Subject: **GLOBAL AMOC for AD 2014-22-51**
Attachments: AD 2014-22-51 Dated January 16 2015
GLOBAL AMOC Dated Nov 12th, 2015
EASB 05A020 Rev 1 dated Oct 22 2015
SB 79-001 mod 074547 dated October 22 2015

2014-22-51 Airbus Helicopters (Formerly Eurocopter France): Amendment 39-18088; Docket No. FAA-2015-0133; Directorate Identifier 2014-SW-066-AD.

EMERGENCY ALERT SERVICE BULLETIN

SUBJECT: ENGINE LUBRICATION - Engine/MGB oil cooling fan

Figure 1

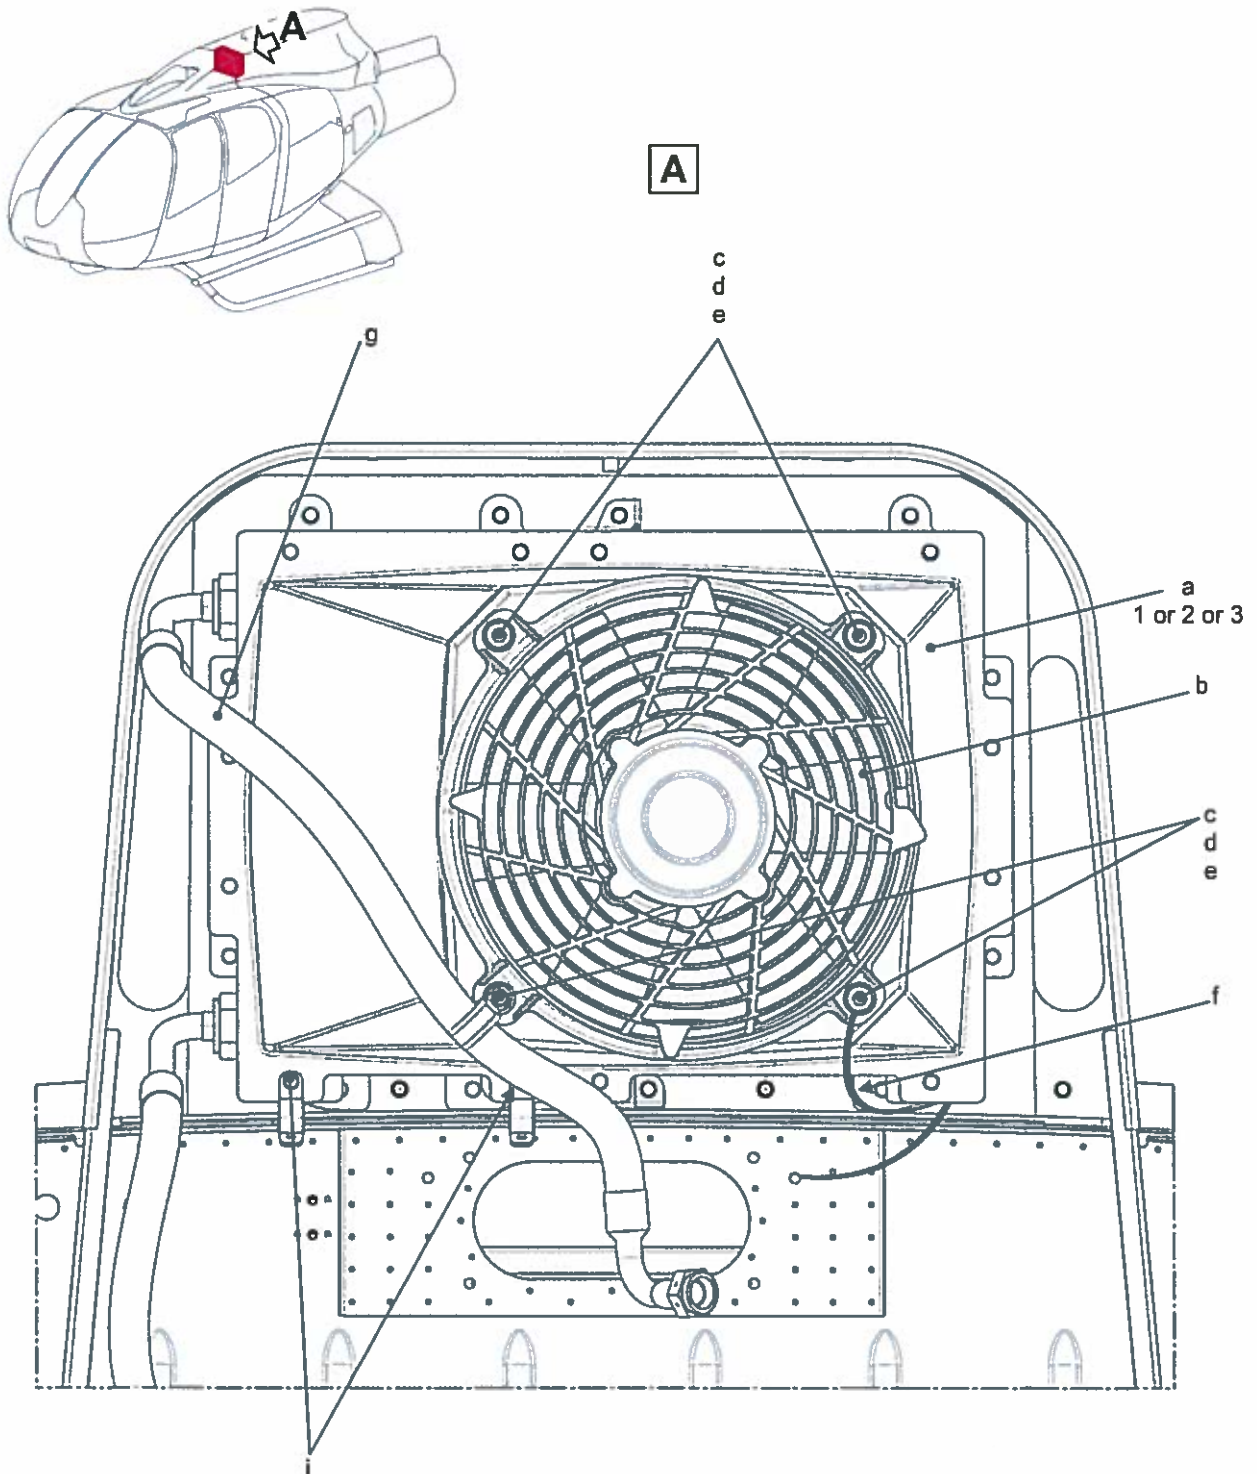
- Check for cracks the hopper (a) (Figure 1) especially at the attachments of the fan (b):

- Replace the hopper (a):
 - . Replace the hopper (a) (Figure 1) with hopper (1), (2) or (3) as per AMM Task 79-21-00, 4-3,
 - . Comply with Service Bulletin No. 79-001 (embodiment of modification 074547).

Figure 2

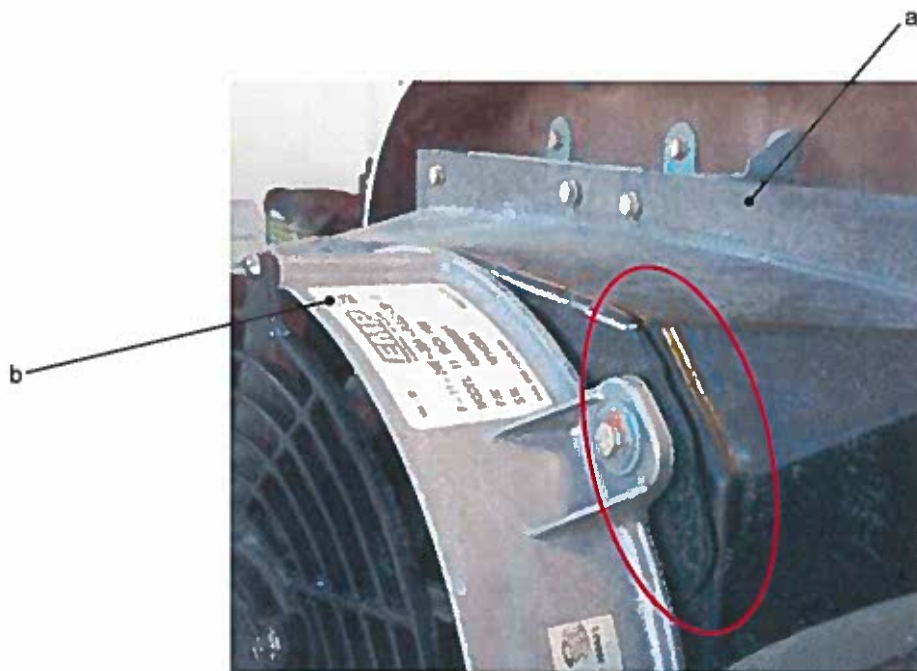
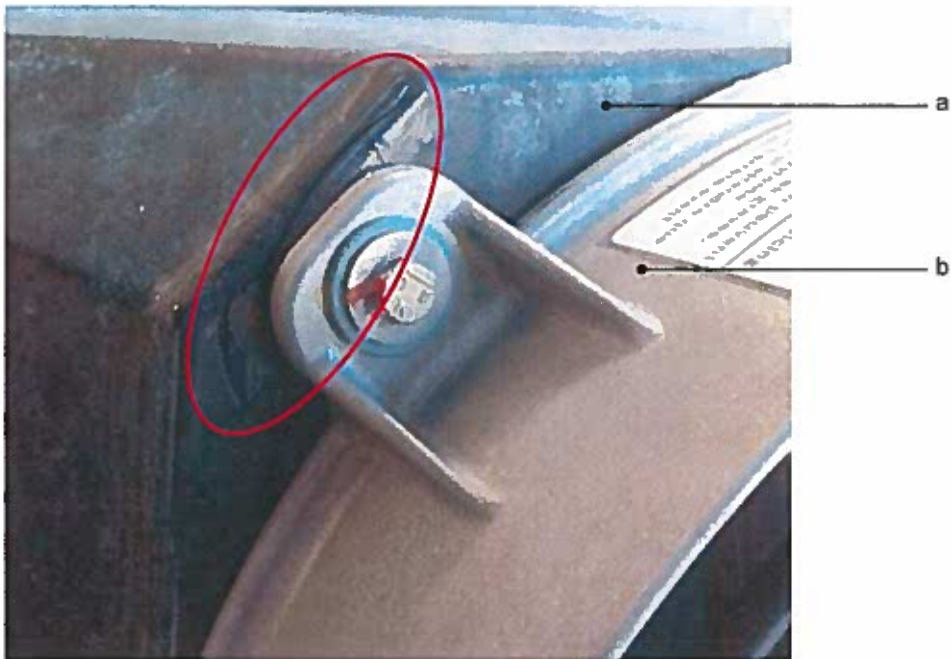
Airbus Helicopters has been informed of several cases of cracks at the attachment points of the fan to the hopper. (See examples of cracks, [Figure 2](#)).

- . For the lower part of the hopper:
 - Open the LH and RH MGB cowlings.
- Analysis of results:
 - . When no cracks are found:
 - Leave as is.
 - . When cracks are found (see examples, Figure 2):

Figure 3

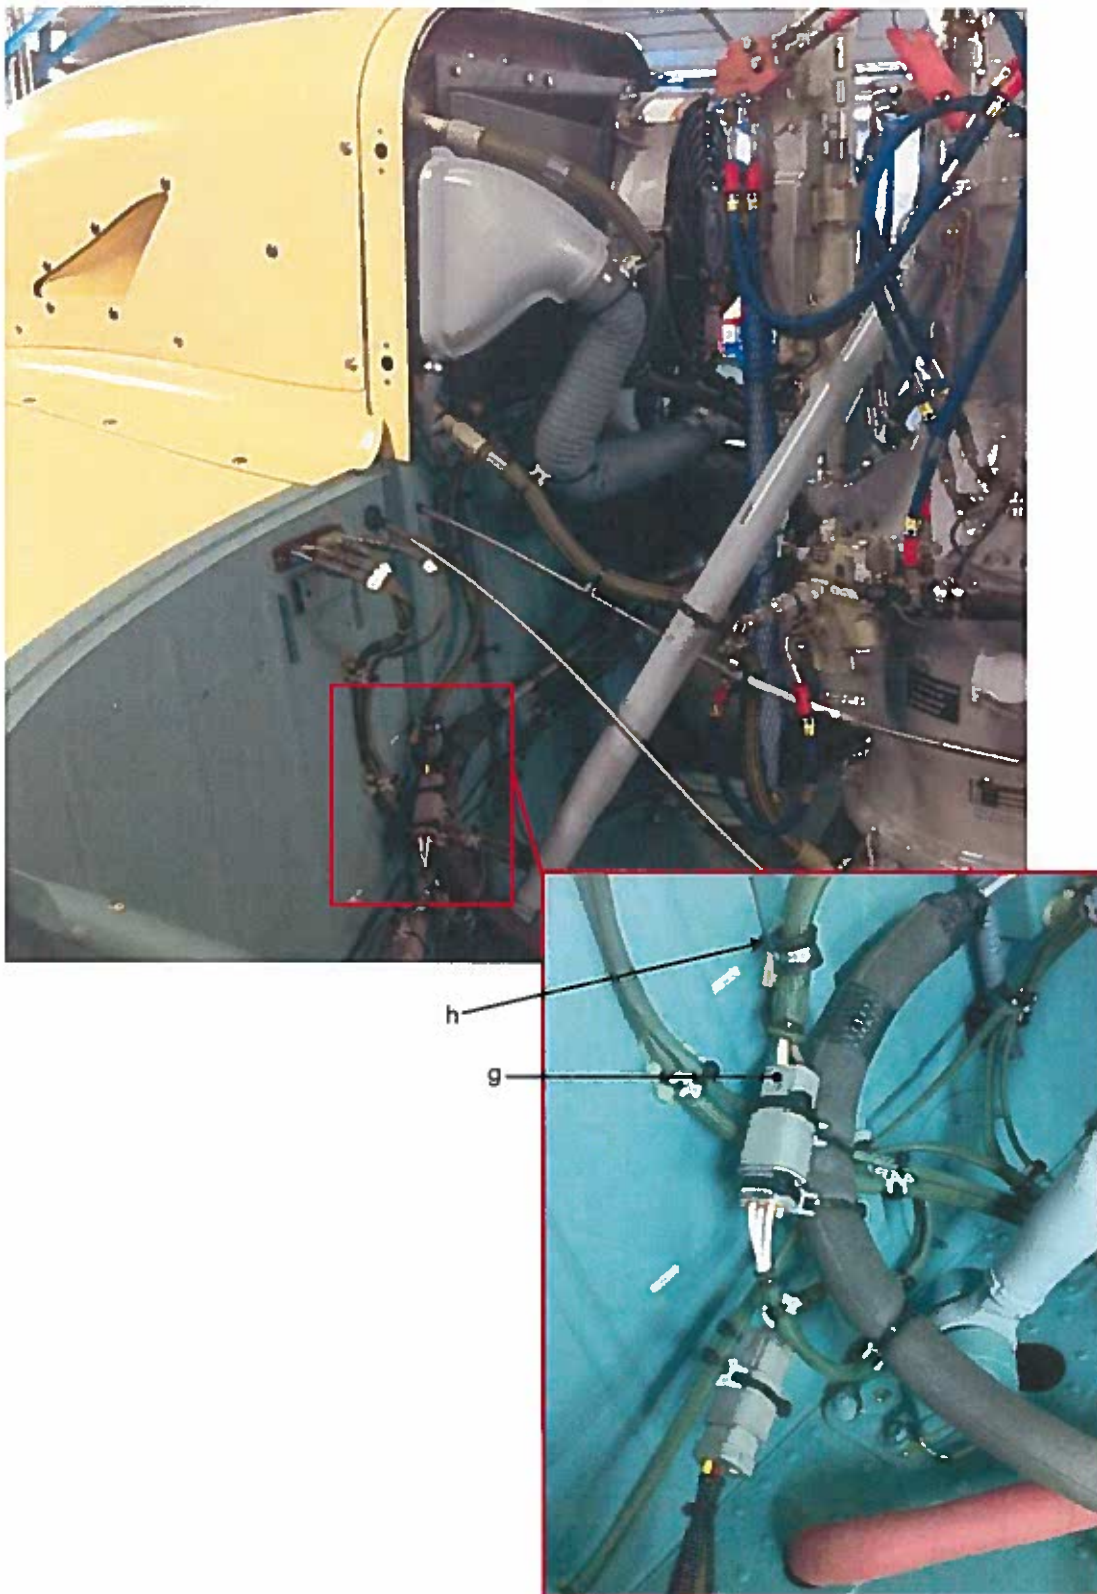
- . Remove the clamps securing the fan electrical harness and the clamp securing the electrical connector (g) (Figure 3).
 - . Disconnect the electrical connector (g) of the fan, and remove the shielding continuity (h) from the structure.

Figure 1

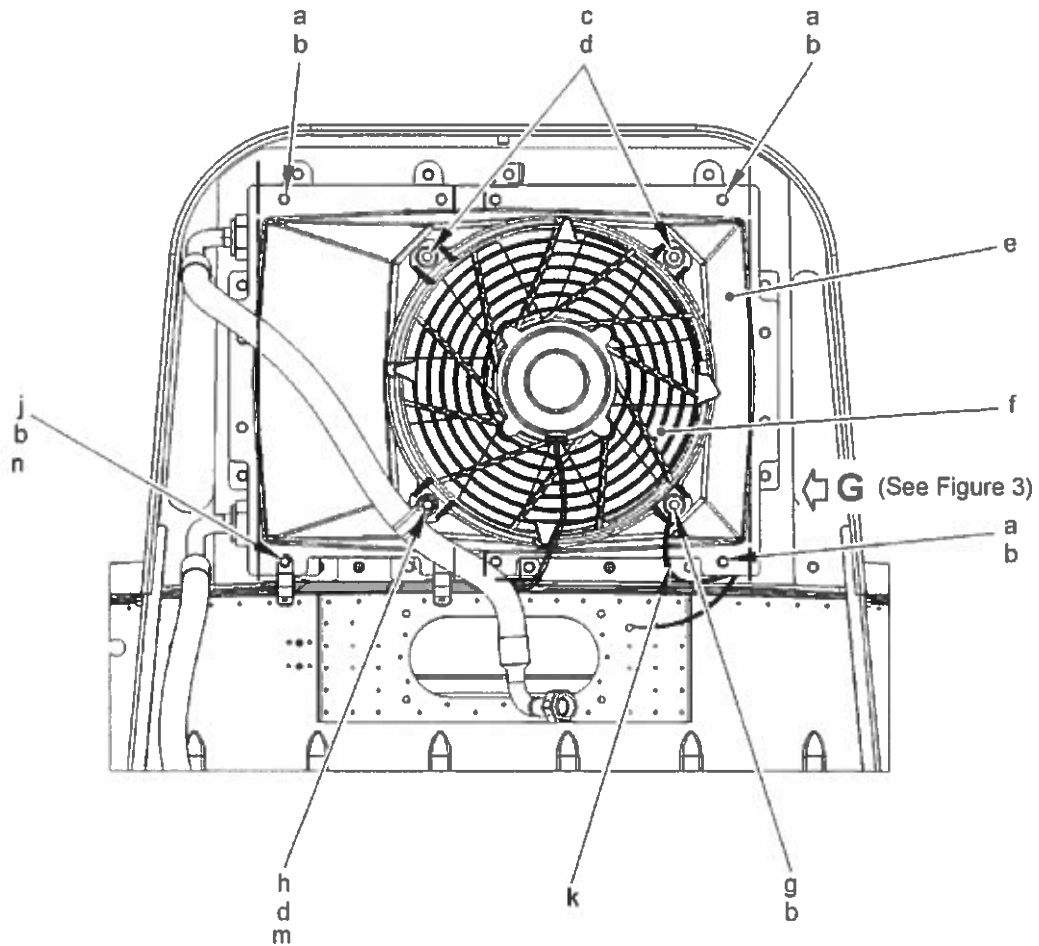
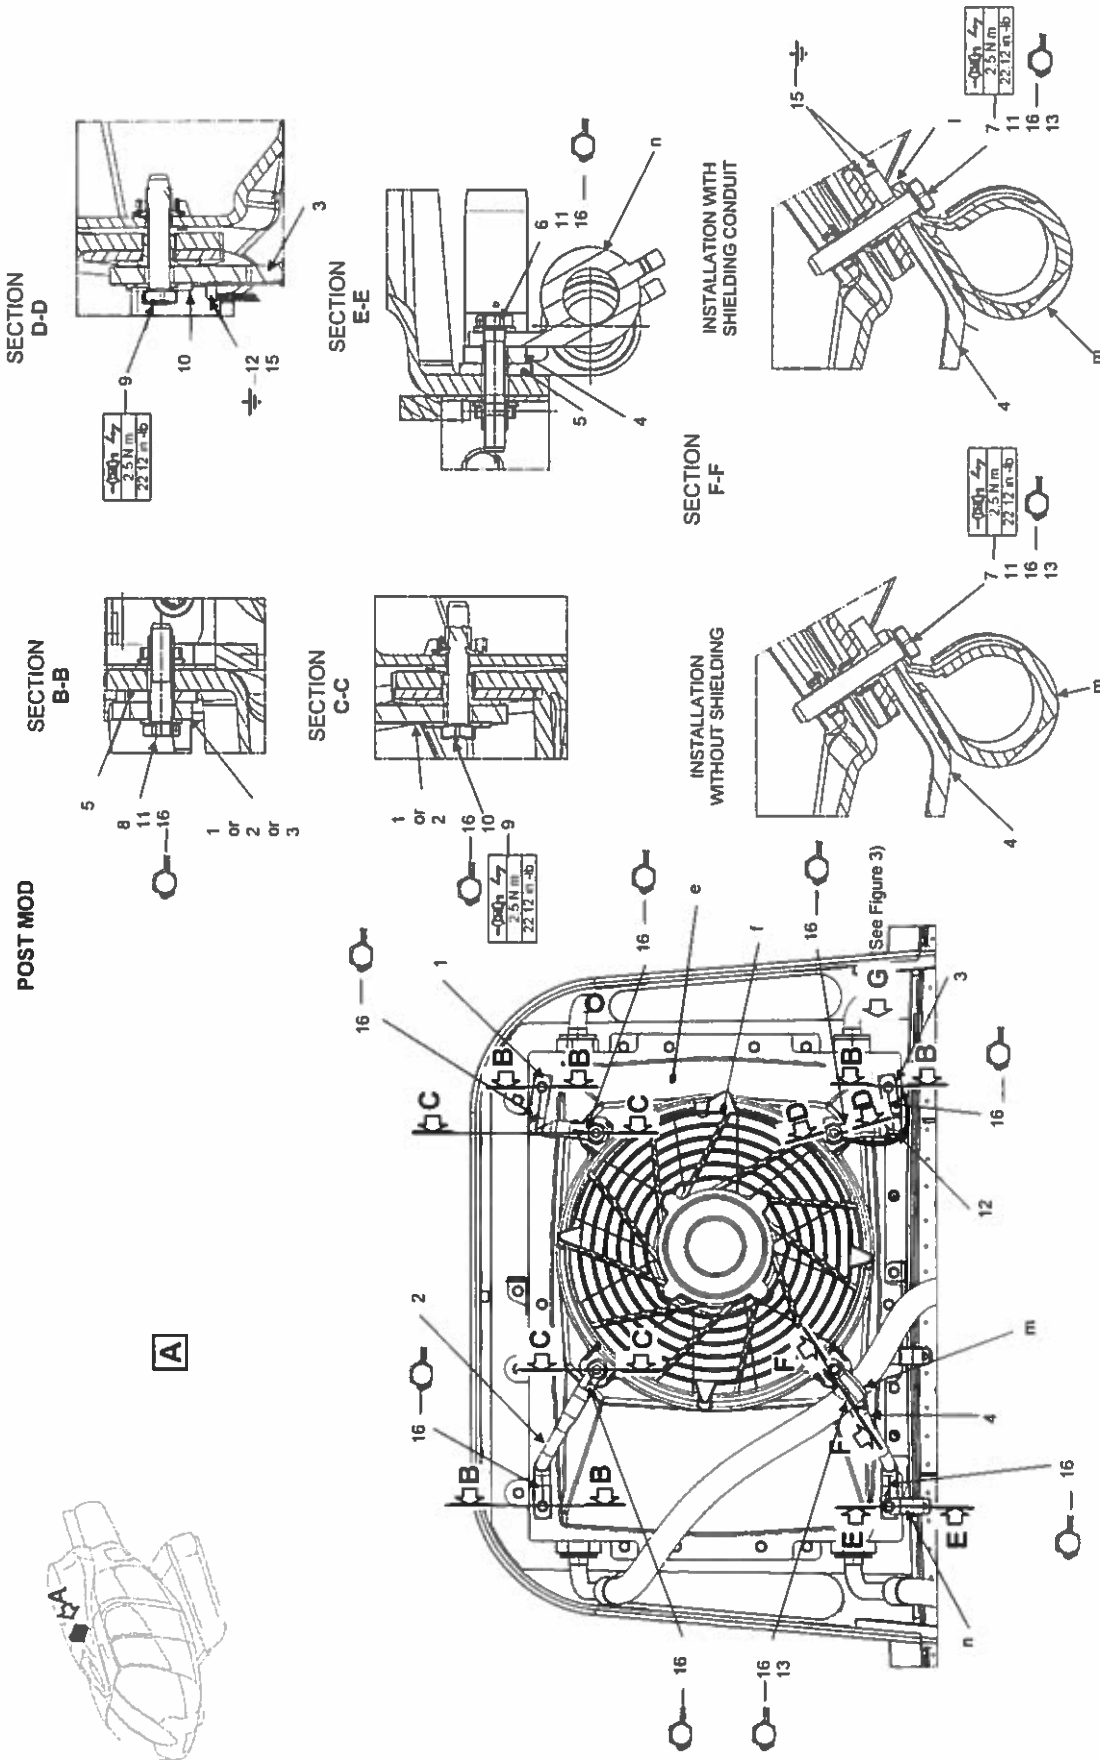
Addition of four stainless steel attachment rods between the fan and the cooler.
A laminated shim is, if necessary, inserted between each attachment rod and the hopper on the cooler attachment, to compensate for manufacturing dispersions and avoid an assembly with constraints.

- Remove and scrap bolt (a) and washer (b) from hopper (e).
- Remove and scrap bolt (c) and washer (d) from fan (f).

- Hold in contact upper left rod assembly (2) on the cooler side with washer (11) and bolt (8) and tighten bolt (8) without tightening torque.
- Measure clearance on the fan side.
- Remove bolt (8), washer (11) and upper left rod assembly (2).

- Install adjusted laminated shim (5) on the cooler side and upper left rod assembly (2).
- On the cooler side, install washer (11) and bolt (8) as per section B-B.
- On the fan side, install washer (10) and bolt (9) as per section C-C.
- Tighten bolt (8) to standard torque as per section B-B.
- Torque bolt (9) as per section C-C.
- Safety bolts (8) and (9) with lockwire (16) (see safetying principle on page 9).

Figure 3

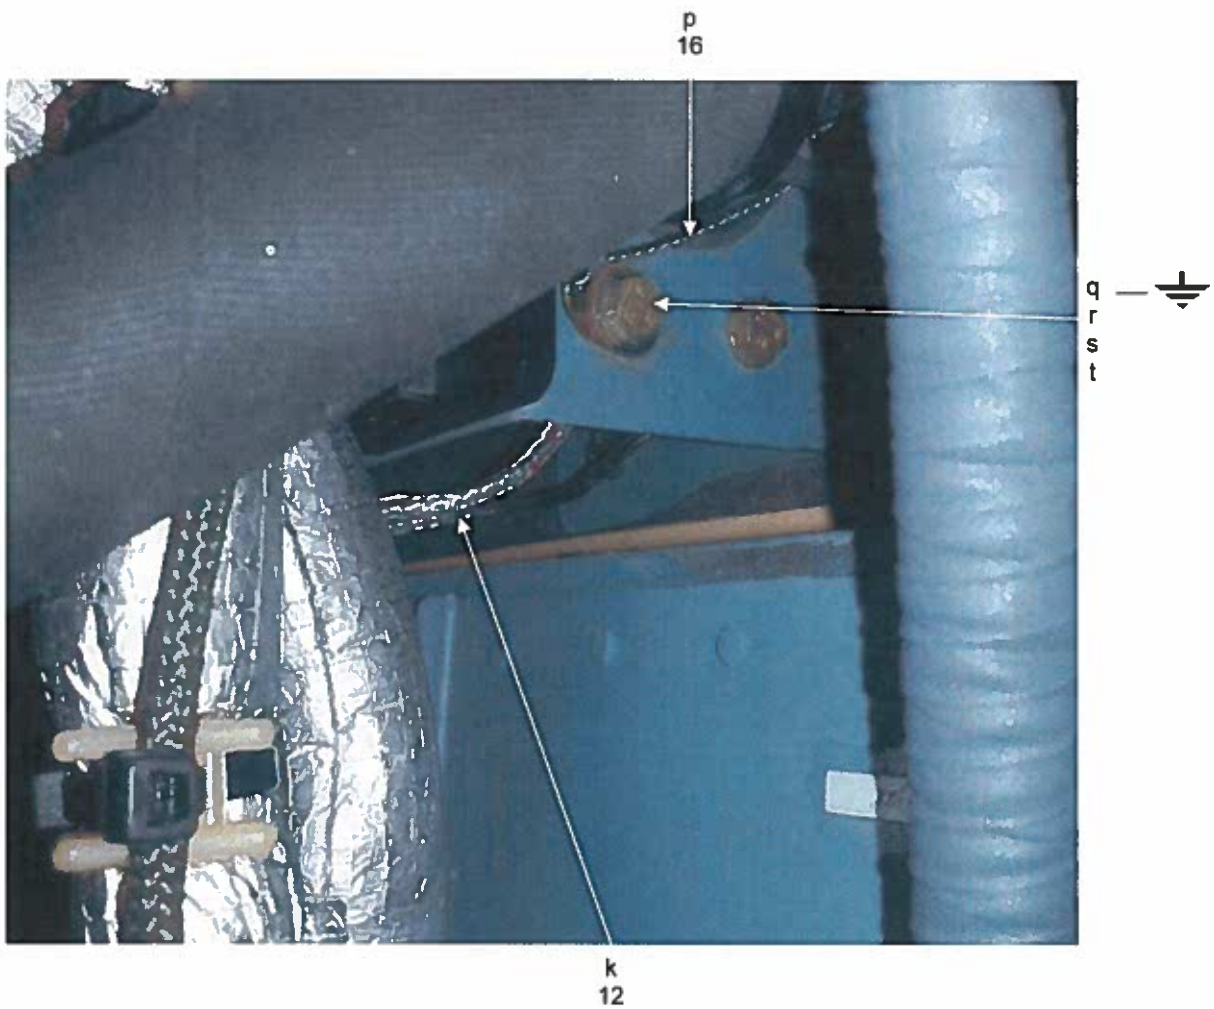
- Remove and scrap bolt (a) and washer (b) from hopper (e).
- Remove and scrap bolt (g) and washer (b) from fan (f).
- Remove and scrap bonding braid (k):
 - . cut and scrap lockwire (p) as per Detail G, Figure 3,
 - . remove and retain bolt (q), washer (r), attachment plate (s) and nut (t),
 - . remove and scrap bonding braid (k).

- Install adjusted laminated shim (5) on the cooler side, lower right rod assembly (3).
- On the cooler side, install washer (11) and bolt (8) as per section B-B.
- Electrically bond bolt (q) of bonding braid (12).
- On the cooler side, install bonding braid (12), washer (r), bolt (q), attachment plate (s) and nut (t) as per Detail G, Figure 3.
- Tighten bolt (q) to standard torque.
- Safety up to bolt (q) with lockwire (16).
- On the fan side, install bonding braid (12) washer (10) and bolt (9) as per section D-D, Figure 2.
- Tighten bolt (8) to standard torque as per section B-B.
- Torque bolt (9) as per section D-D.
- Check electrical continuity between bonding braid (12) and hopper (e), the ohmic value must be lower than 1.5 m Ω (milliohm).
- Apply varnish (15) to bonding braid (12) attachments as per MTC Work Card 20.02.07.403.
